Approval No.: 19897/2021/MCU

Eden Academy Brassall
102-104 Pine Mountain Road, Brassall Q
Client
Griffith Group

Elevations

ROOF LEGEND

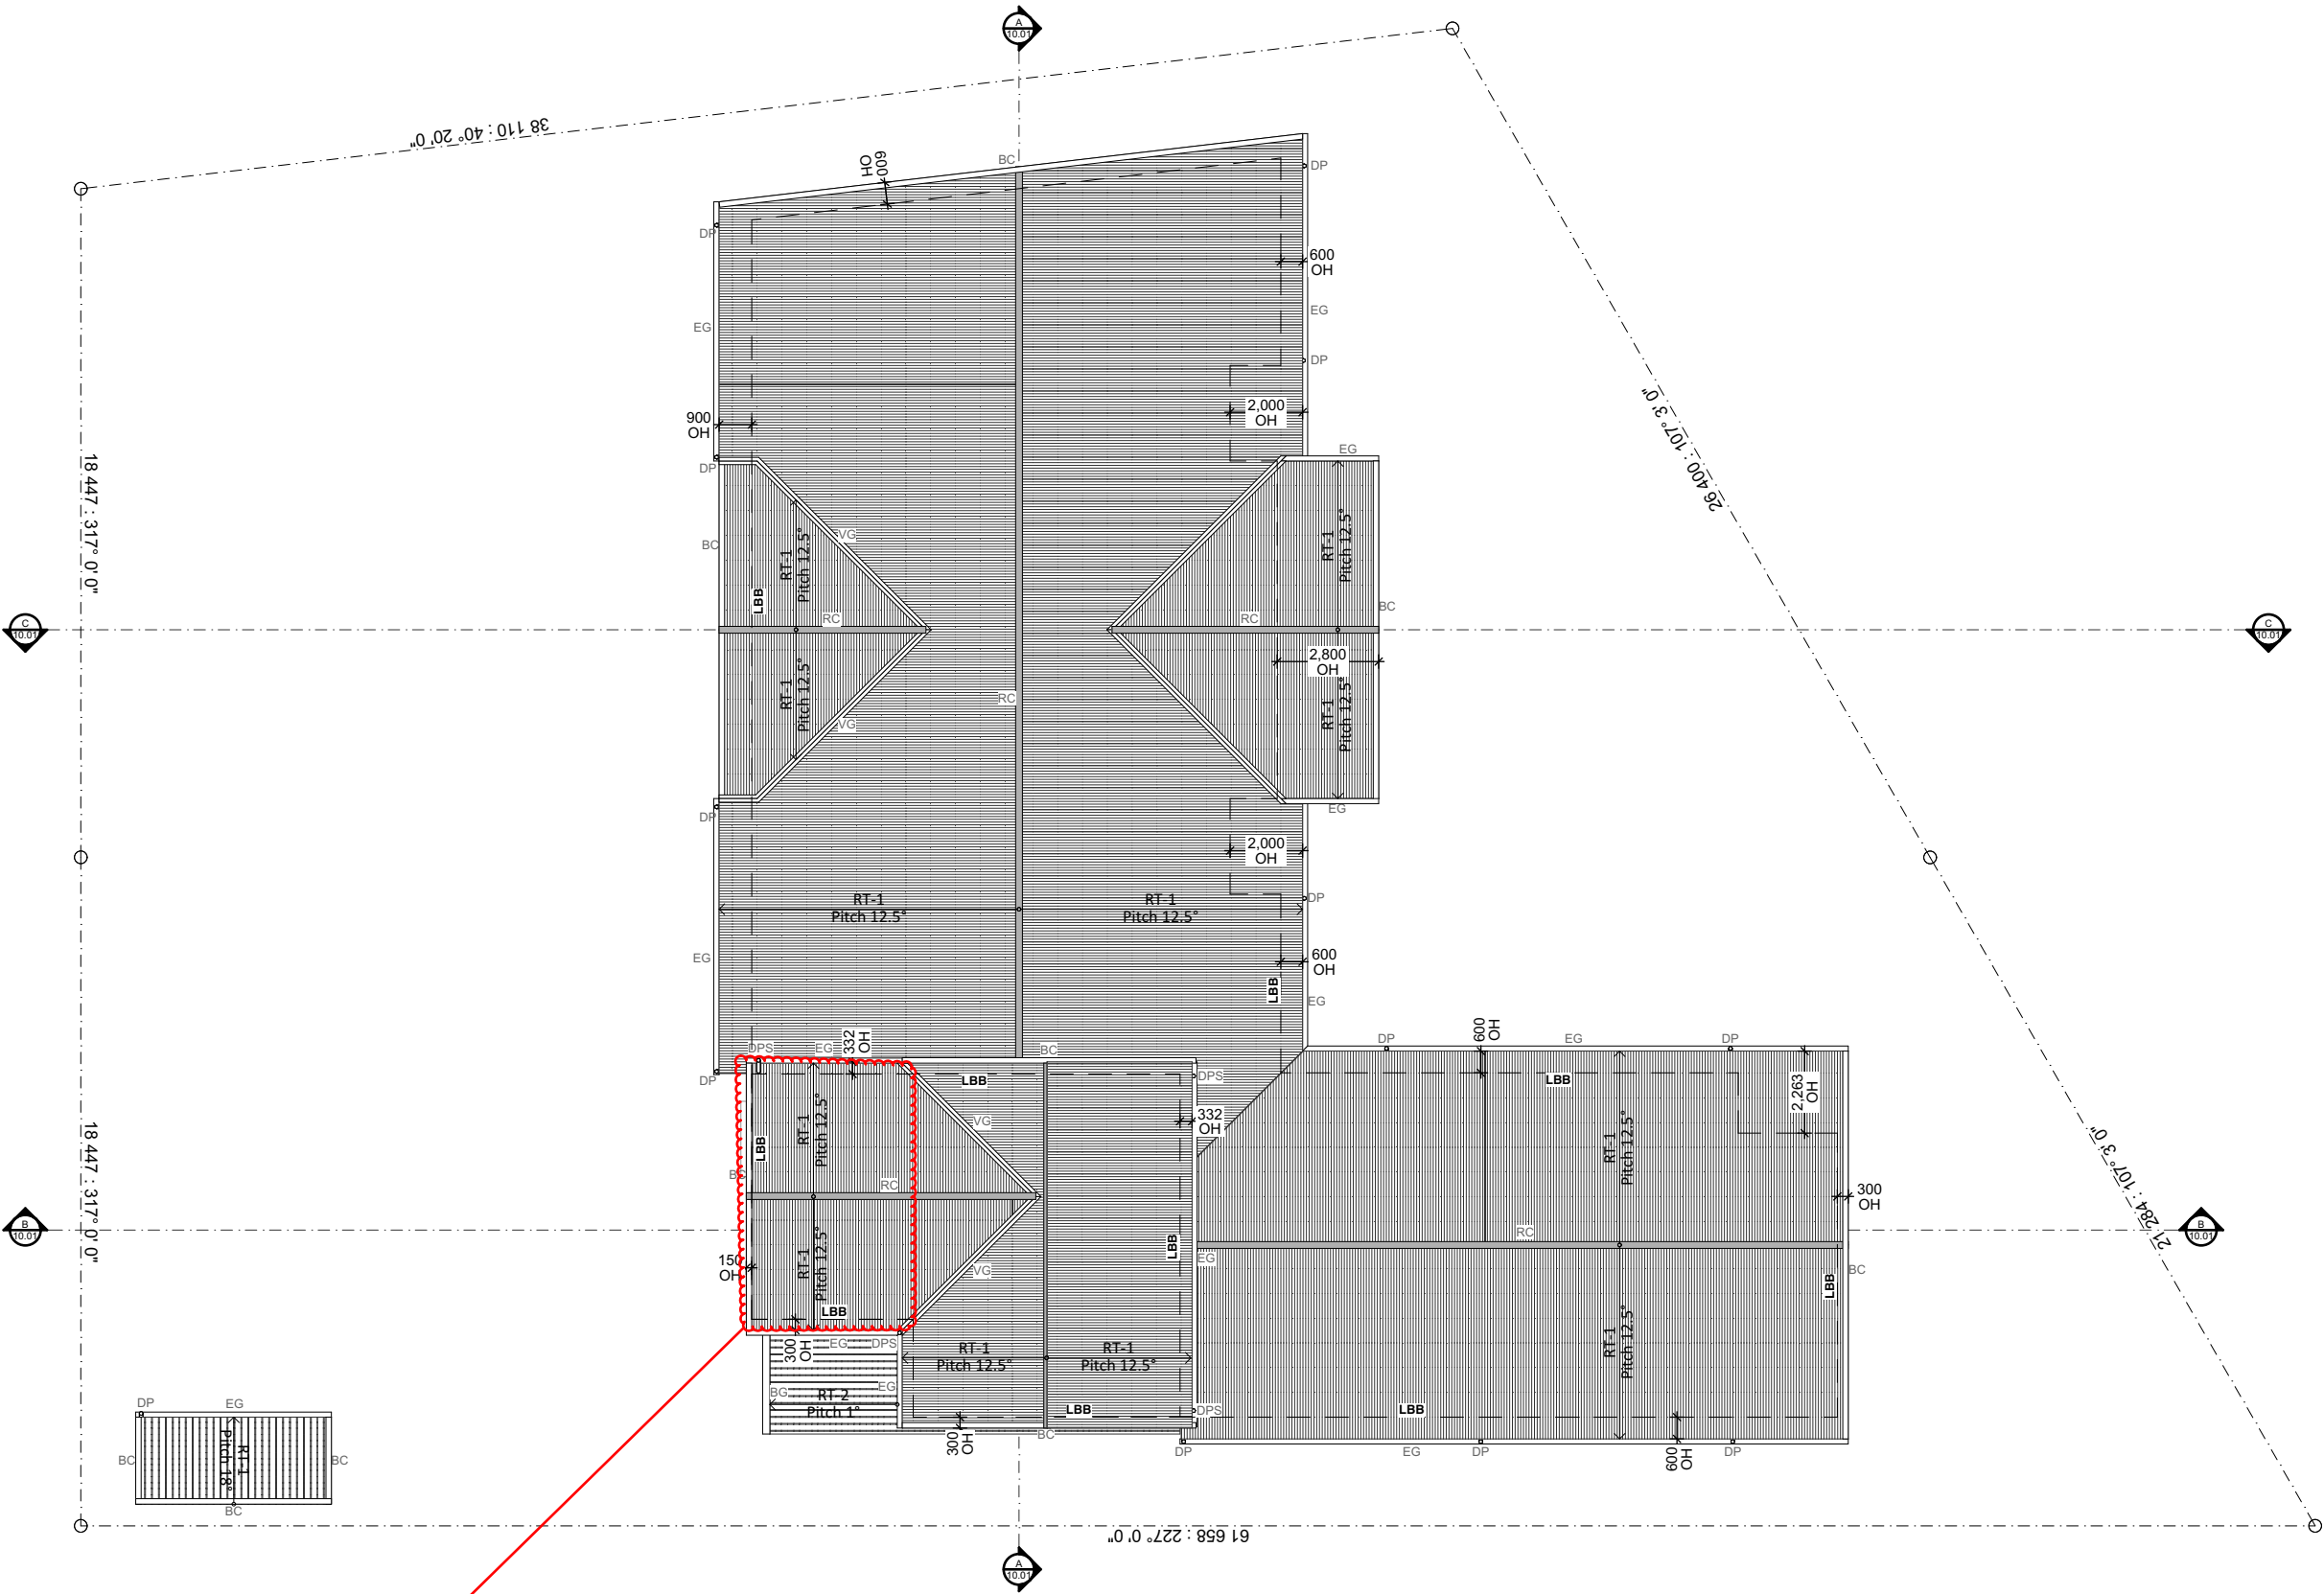
Revised plans to be submitted removing double height void space and establishing a roof line consistent with the rest of the building.

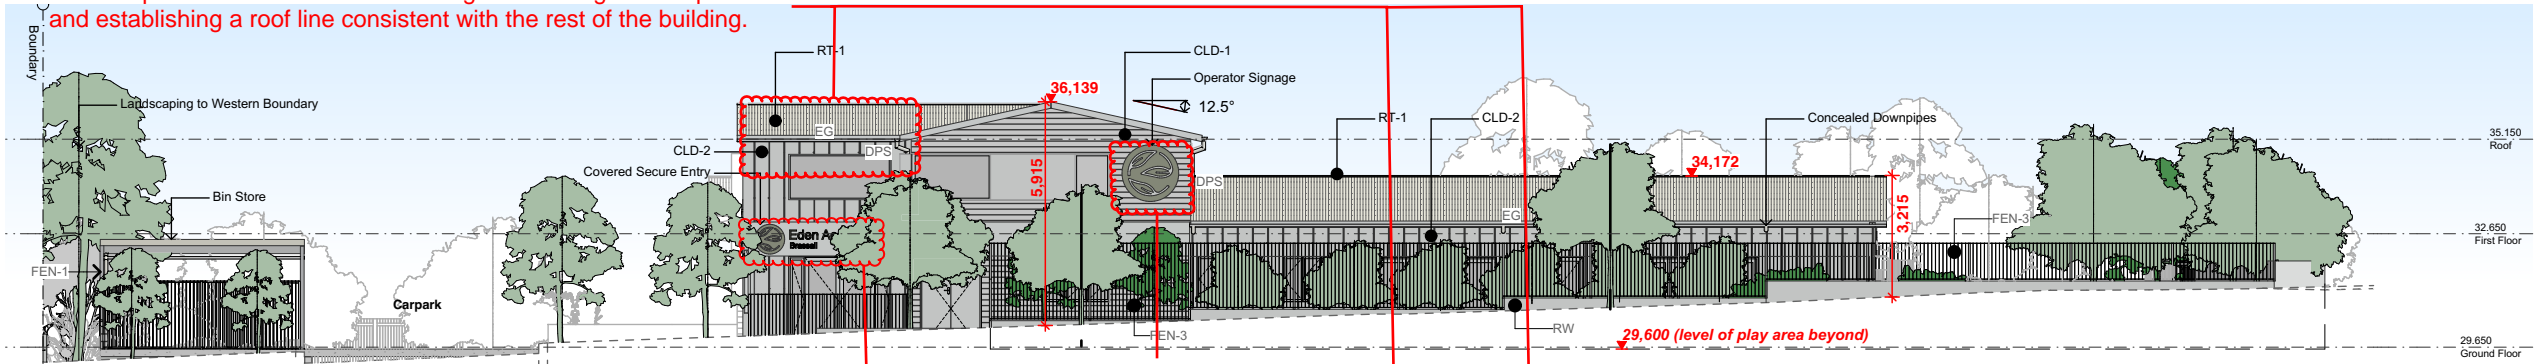
Revised plans to be submitted removing double height void space and establishing a roof line consistent with the rest of the building.

3 West Elevation
Scale 1:200

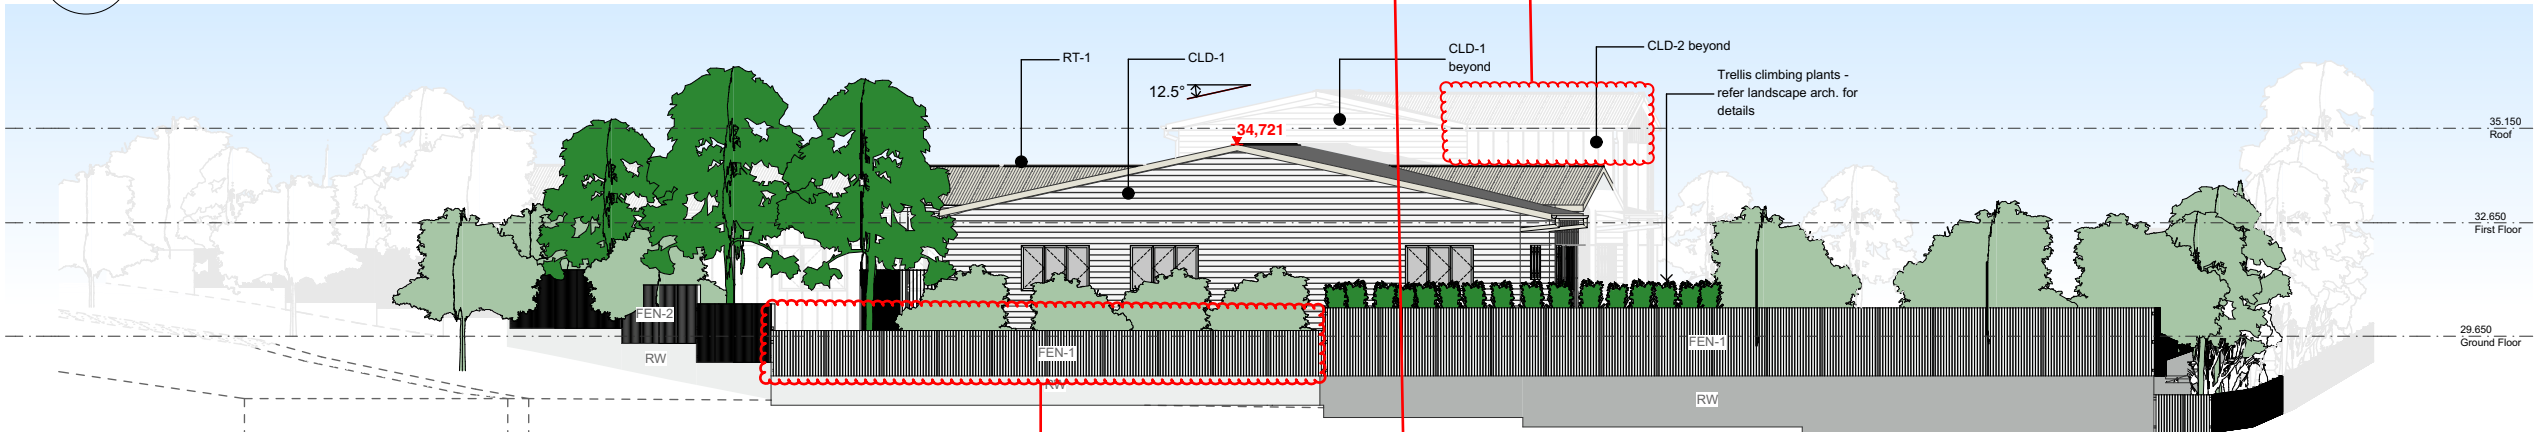
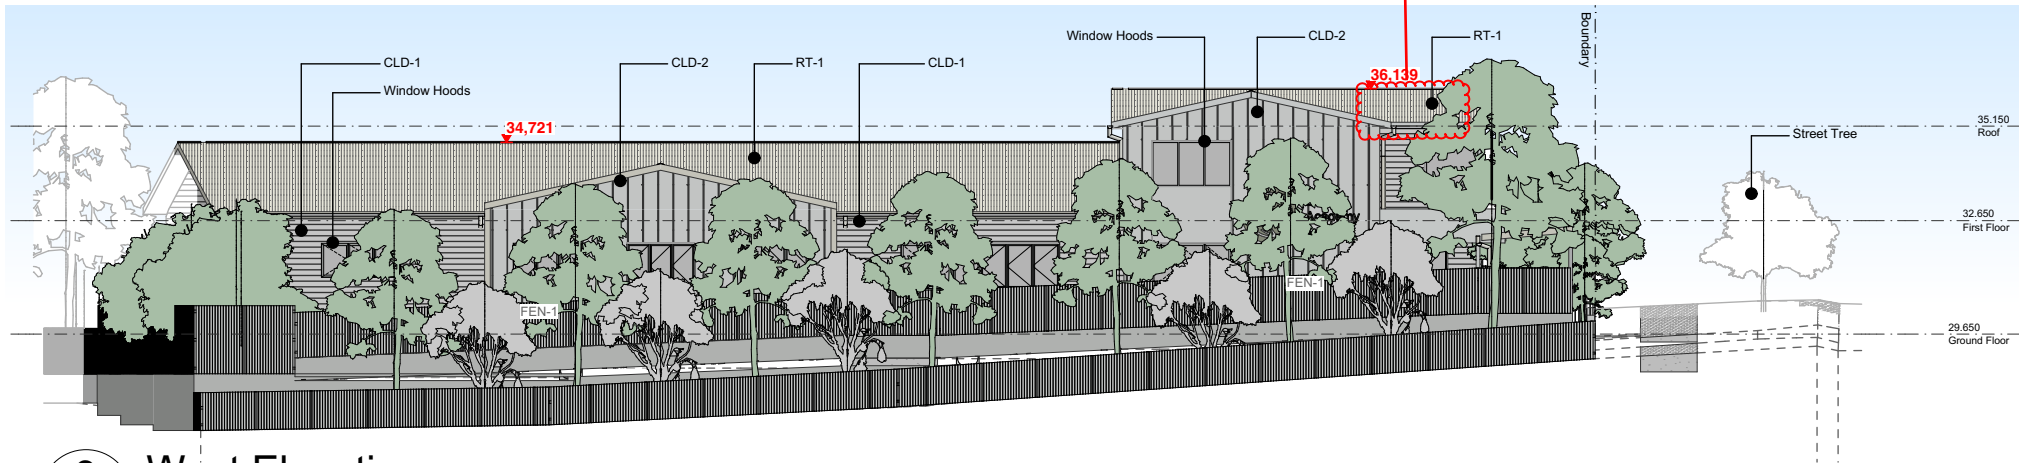
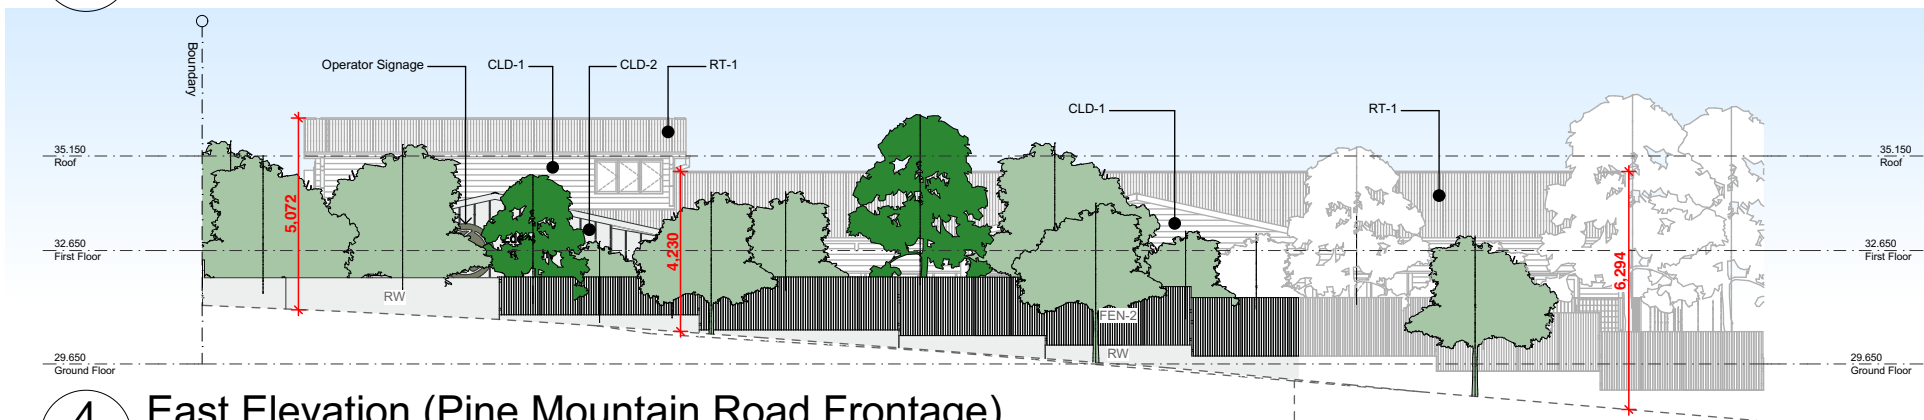
Revised plans to be submitted removing double height void space and establishing a roof line consistent with the rest of the building.

1 Section A
Scale 1:200

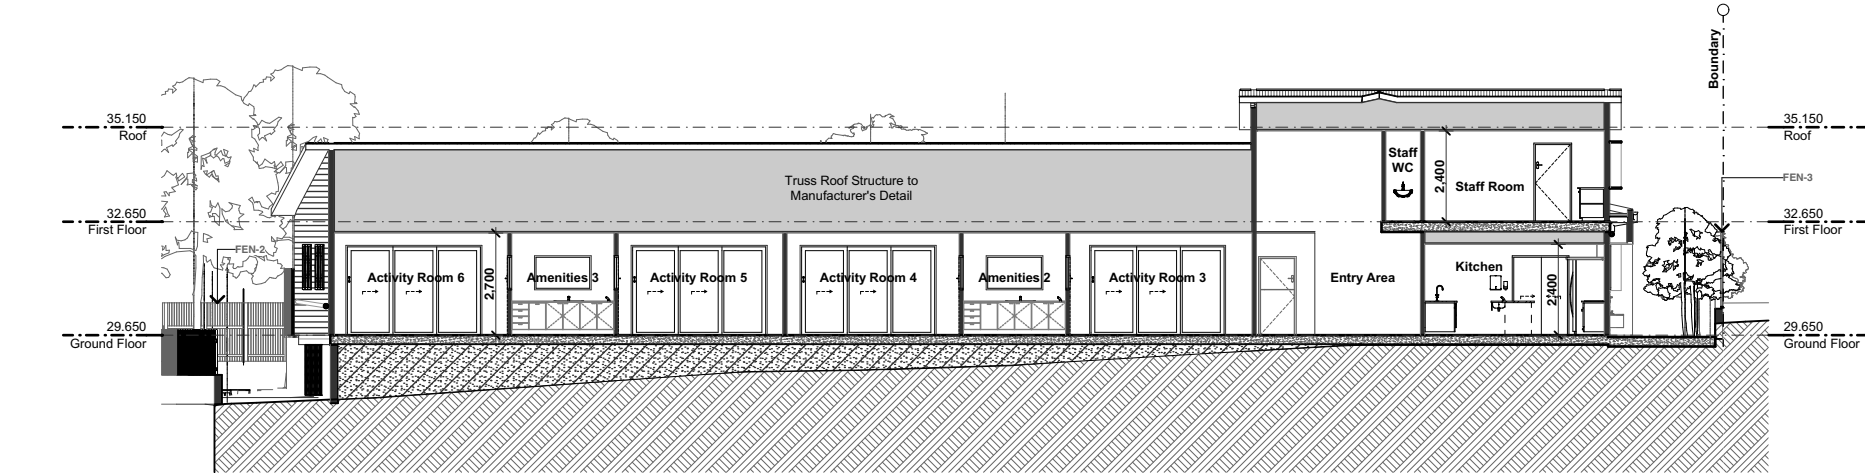
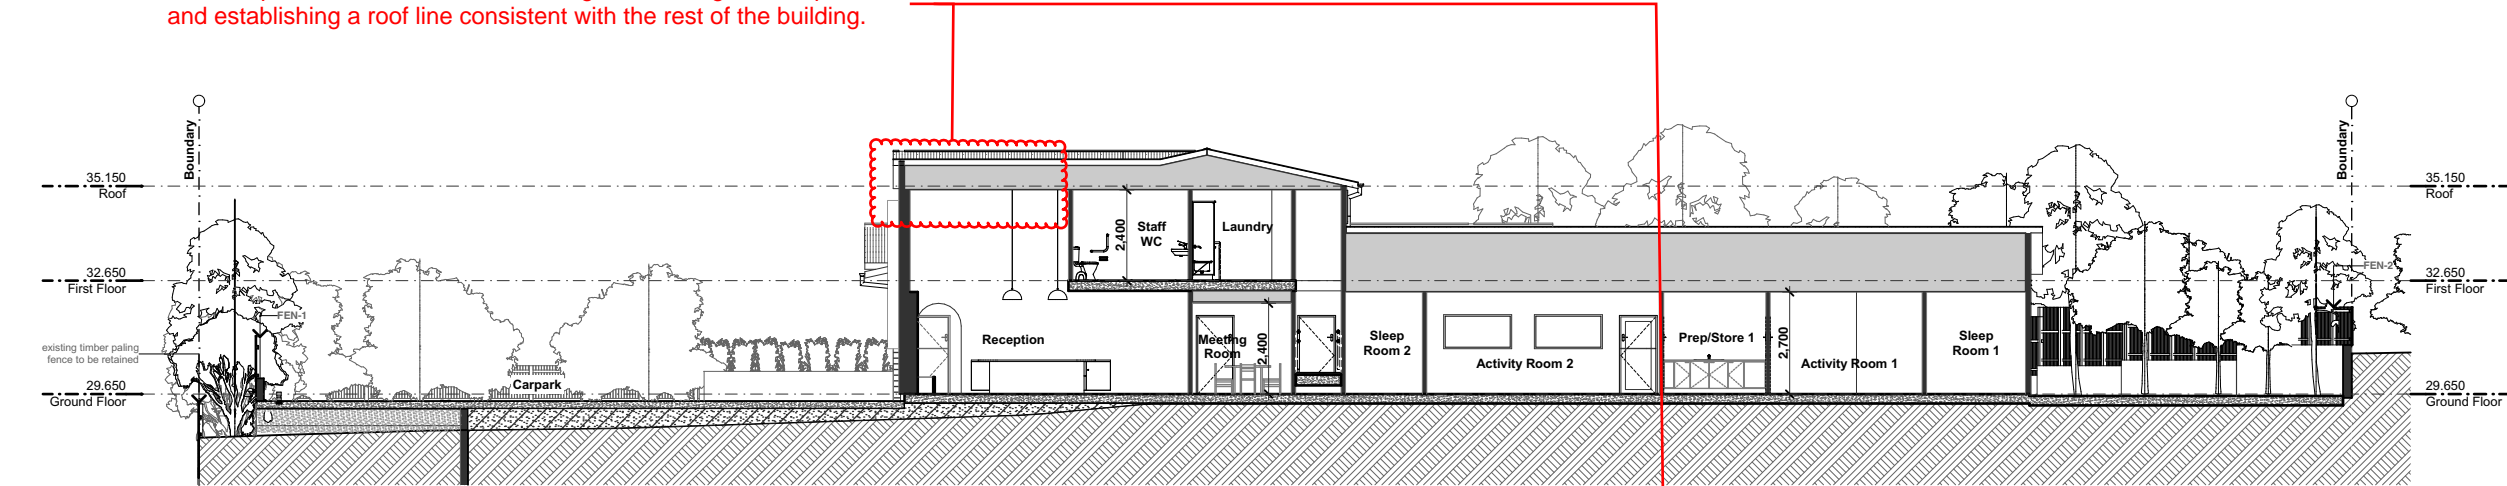
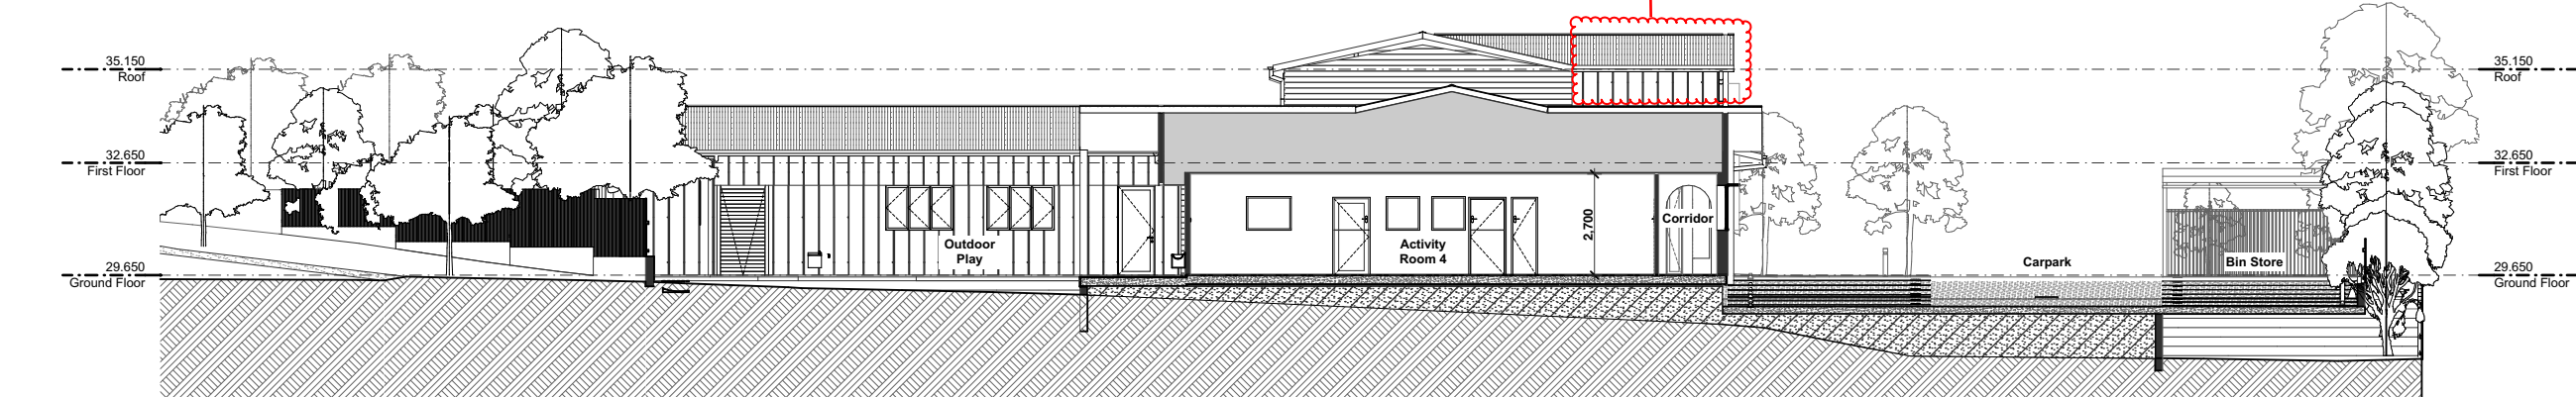
Revised plans to be submitted removing double height void space and establishing a roof line consistent with the rest of the building.
